RE: Preliminary Adequacy Response; M-2004-044

This letter serves as the Preliminary Adequacy Response for the 112c Construction Materials Amendment Application (AM-2), Permit No. M-2004-044. The Preliminary Adequacy Review was summarized in your letter of November 17, 2021. The italicized items are the current comment and the bold text are the responses:

TUCSON SOUTH RESOURCE
PRE-MINING AND MINING PLAN MAPS

EXHIBIT C COVER
SHEET & MINING
NOTES

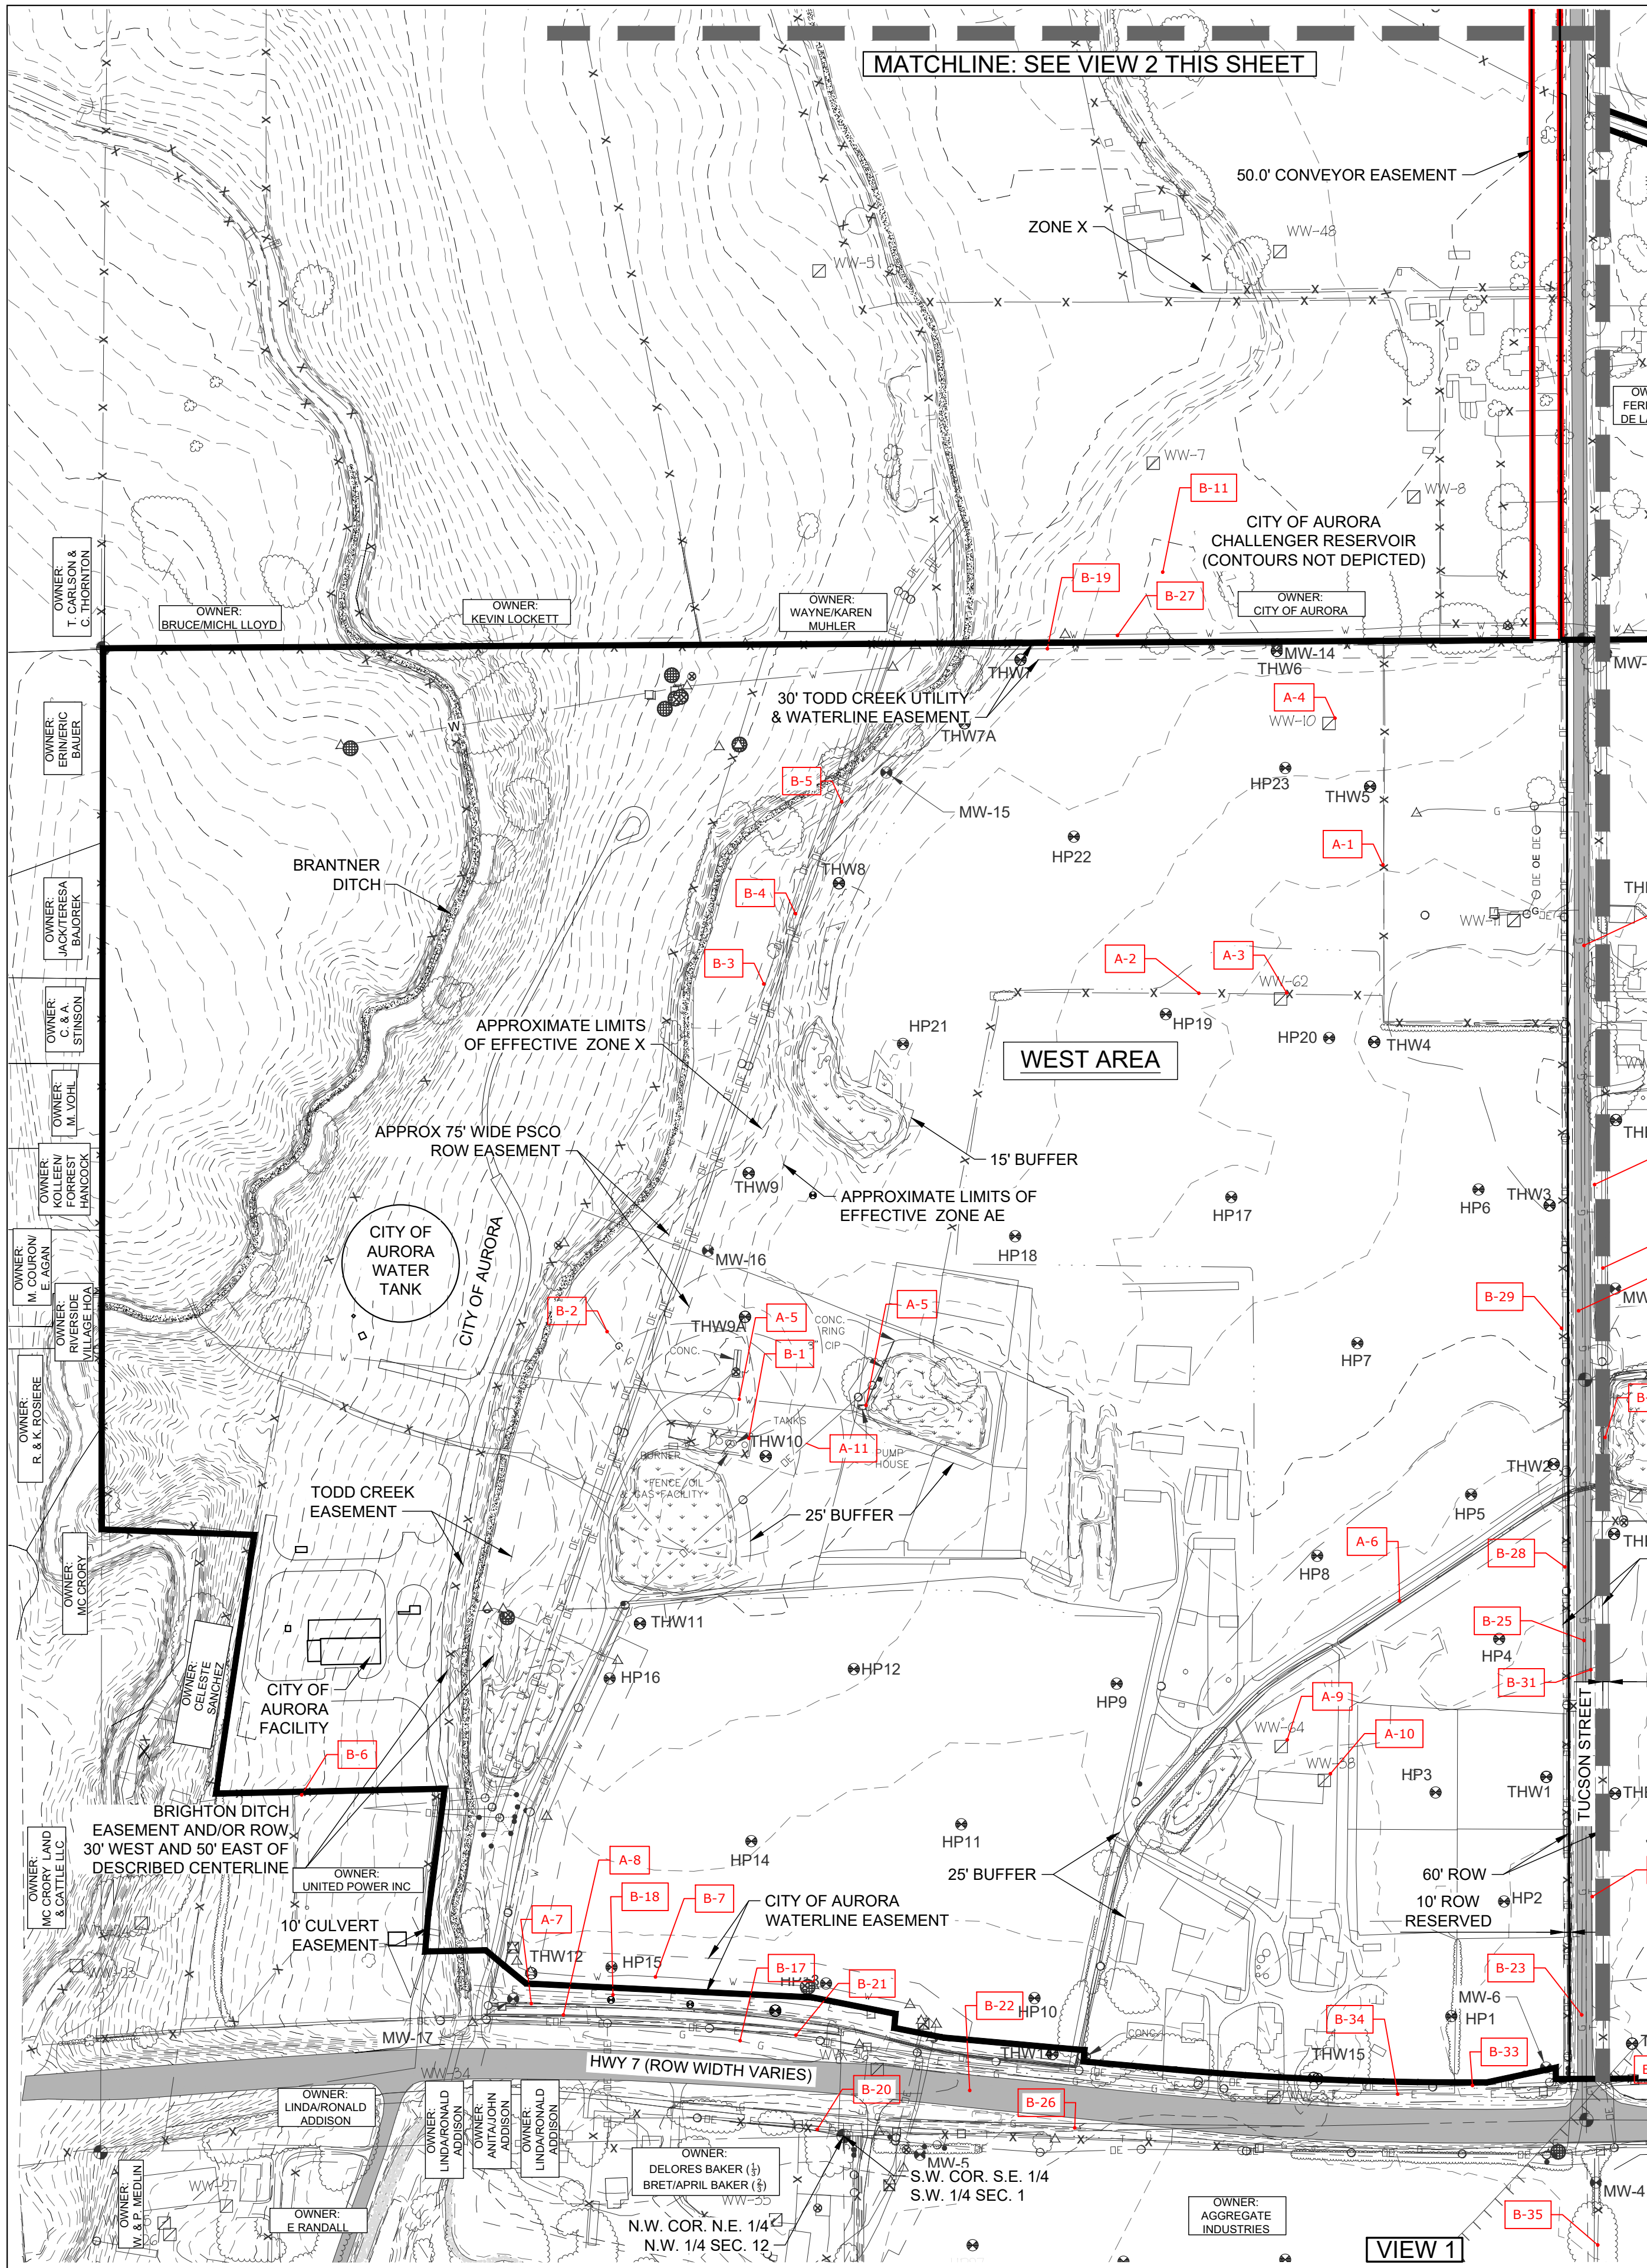
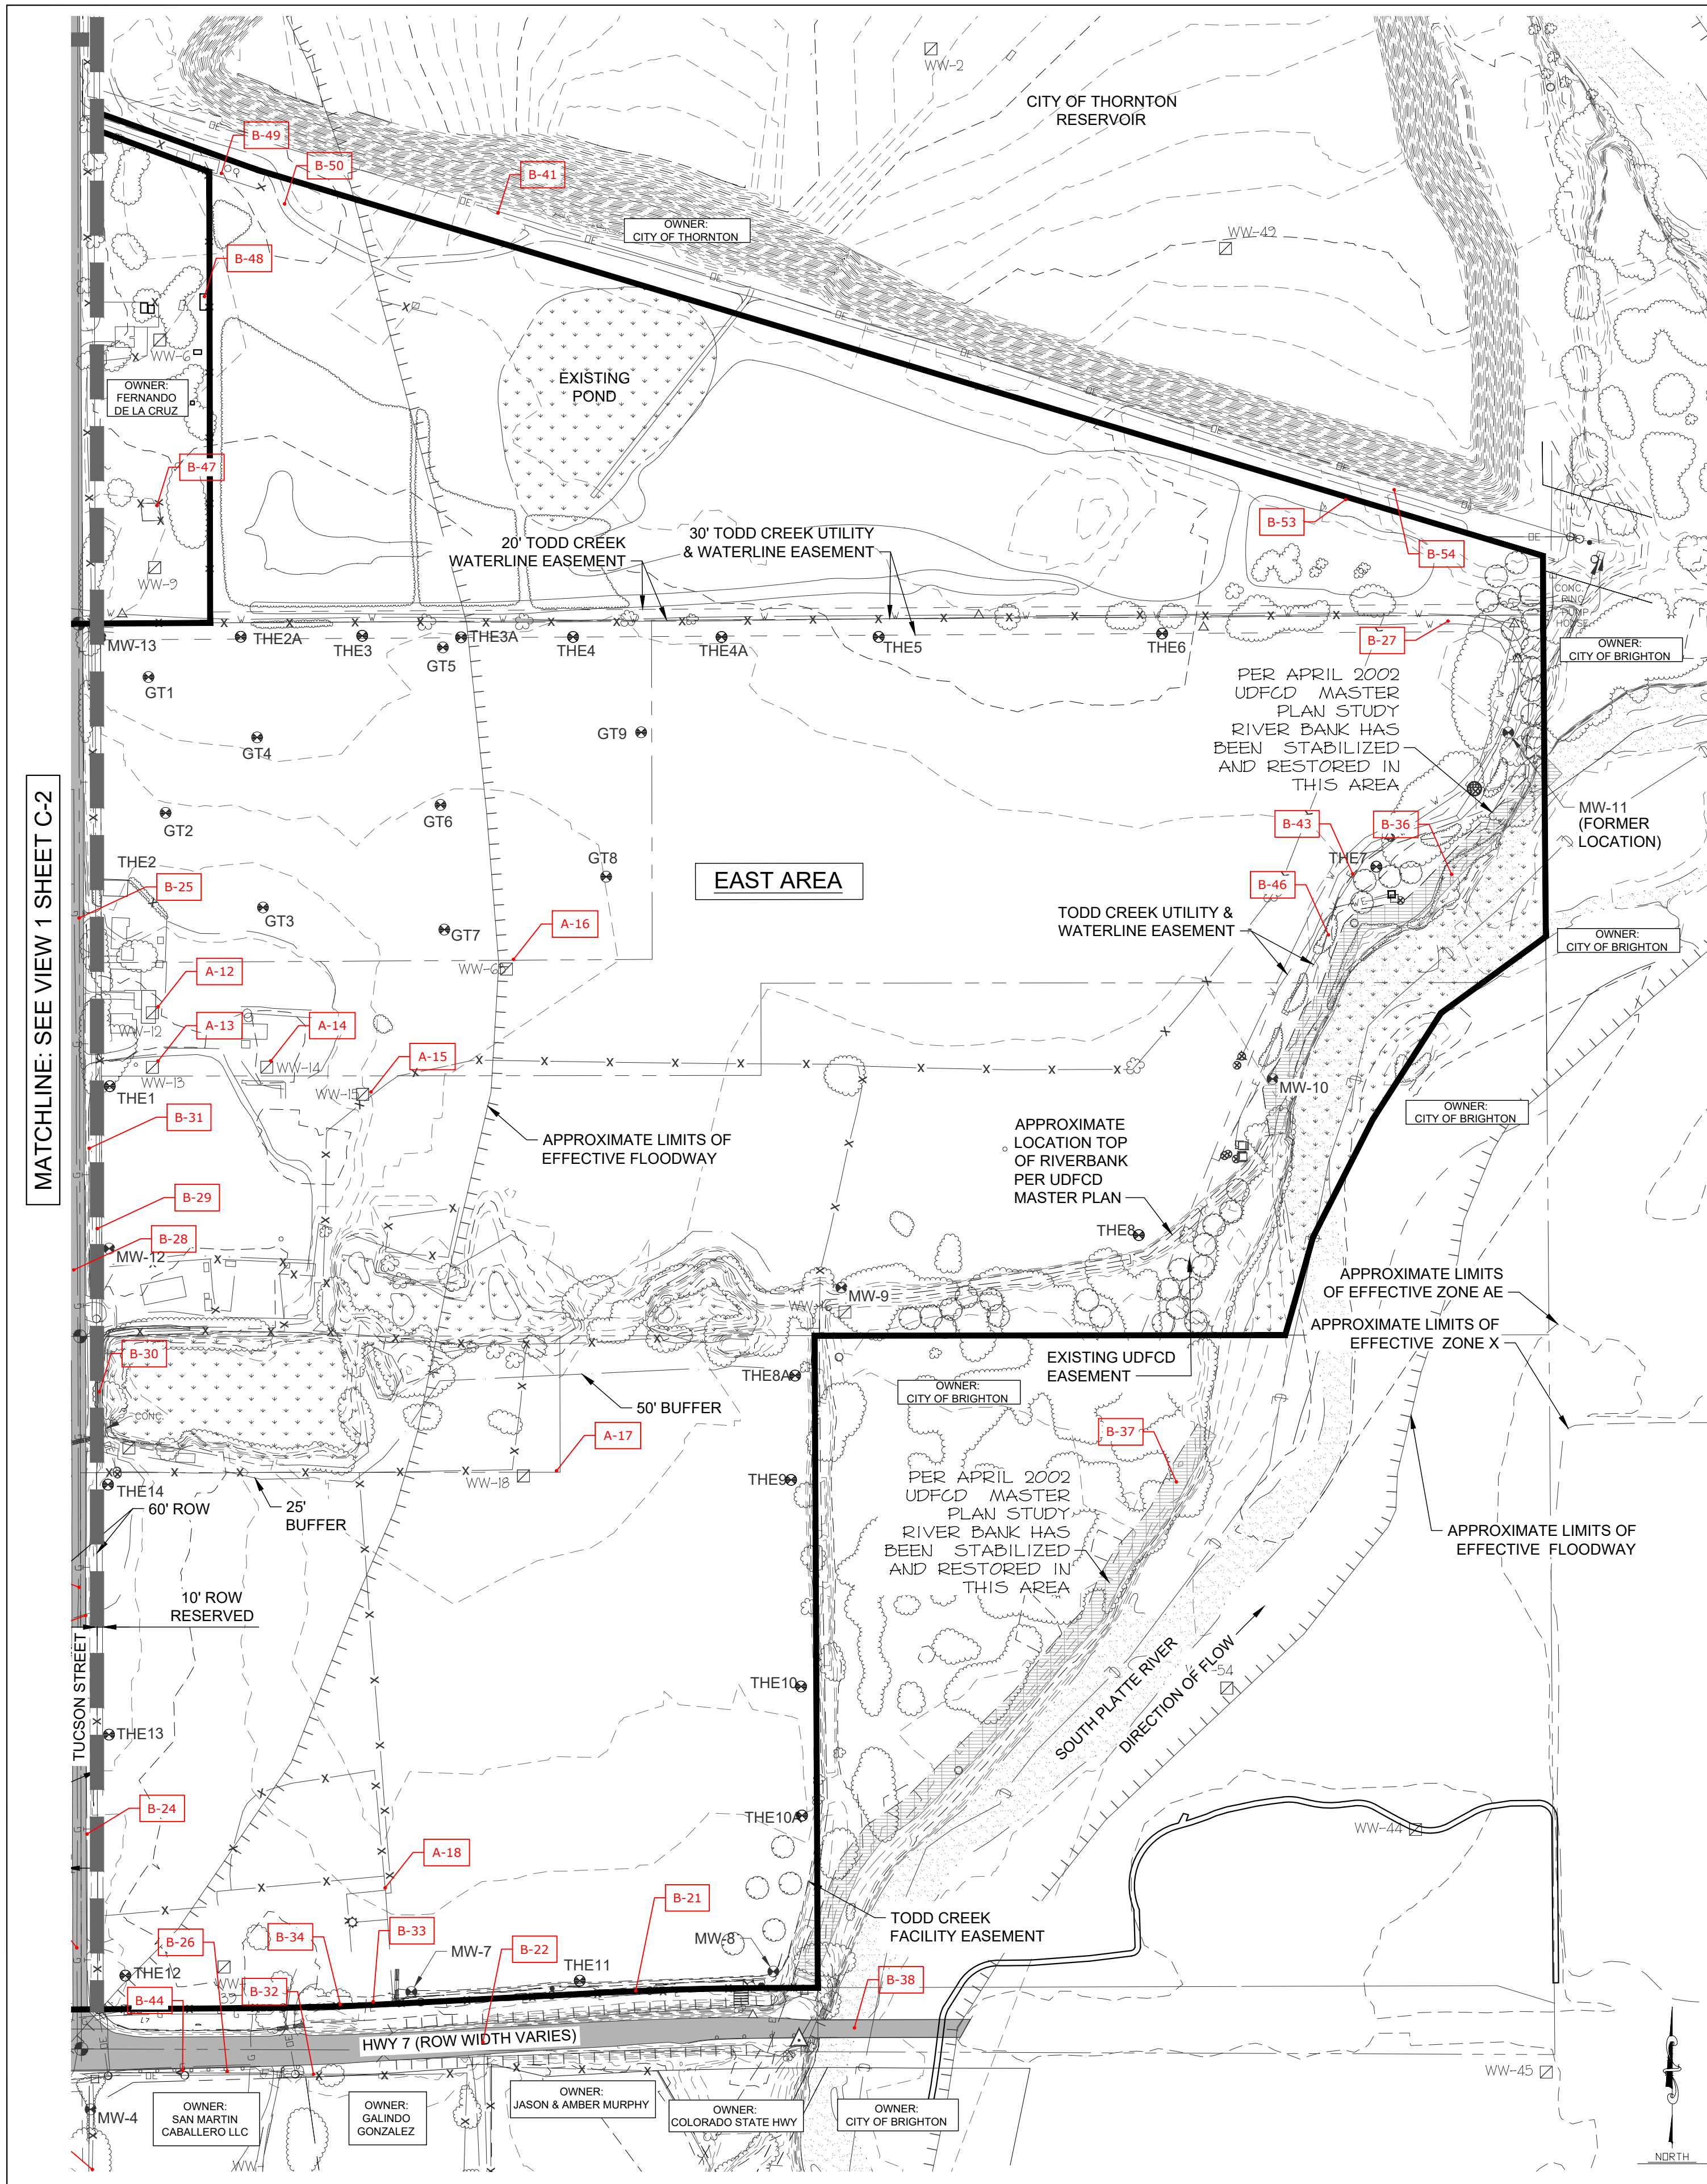
- 2. On the Pre-Mining and Mining Plan Map, C-1, please clearly show the conveyor belt corridor area that is being released through this amendment.*

The area is shown as Tract J on Sheet C-1. Please see attached Exhibit C.
